**Report: PUNCHLIST**  
**Function: Test, Adjust, & Balance**  
**Date: 10/20/2025**  
**Completed By: National TAB**

## Wyler Hyundai Beavercreek (Dayton, OH)

Project: Wyler Hyundai Beaver Creek (Dayton, OH)

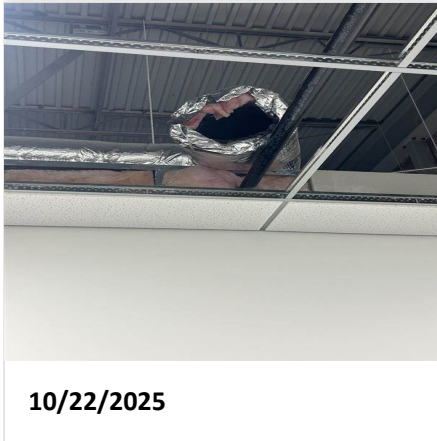
**Issue Name :** RTU-1B diffuser 13 grille not installed  
**Description :** The grille off diffuser 13 is not installed. Unable to balance  
**Created By :** National TAB                      **Assigned To :** National TAB - Corey Dick  
**Status :** Open  
**Priority :** Urgent                                      **Asset Tag :**  
**Originated Date :** 10/22/2025 - Aaron Cosby - National TAB
